Riley Ref: 240065-T
Reissue of: 240065-R

Geomorphic Impacts on Slope Stability Delmore Residential Development Russell Road, Orewa

Table 1: Summary of Updated Slide Analysis Results for Geomorphic Considerations

Table 2: Figures Showing Relative Locations of New Cross Sections

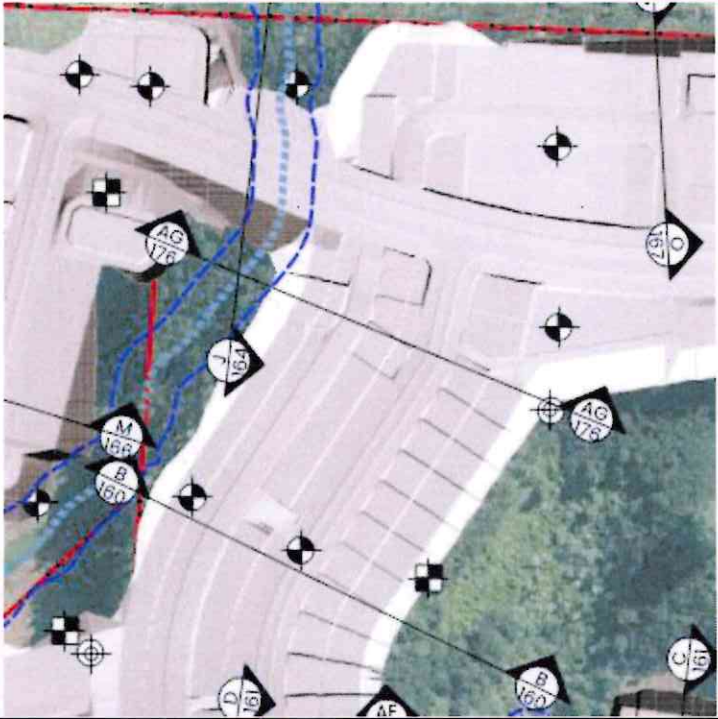
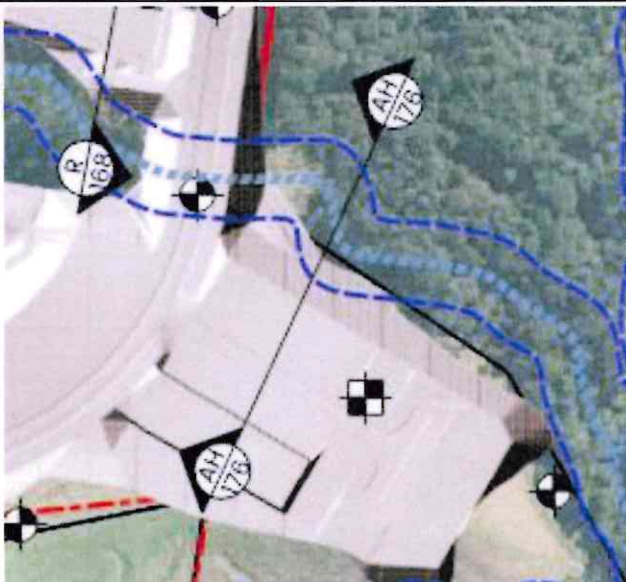
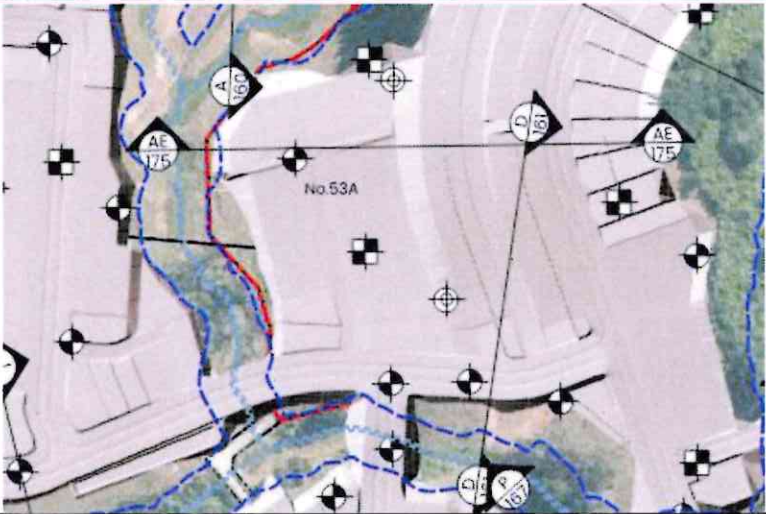
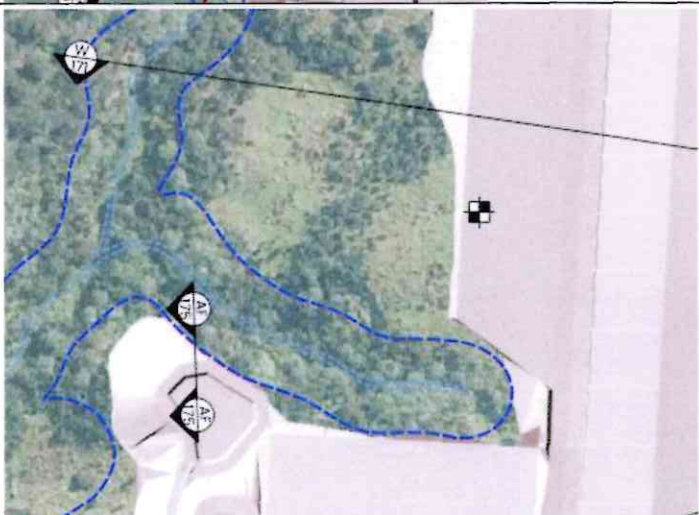
Critical Level ¹	Reach ¹	Cross Section	Cross Section Location ²
Red	2	AG (NEW)	
Red	36	AH (NEW)

Critical Level ¹	Reach ¹	Cross Section	Cross Section Location ²
Green	4	AE (NEW)	
Green	13-14	AI (NEW)	
Green	32	AF (NEW)
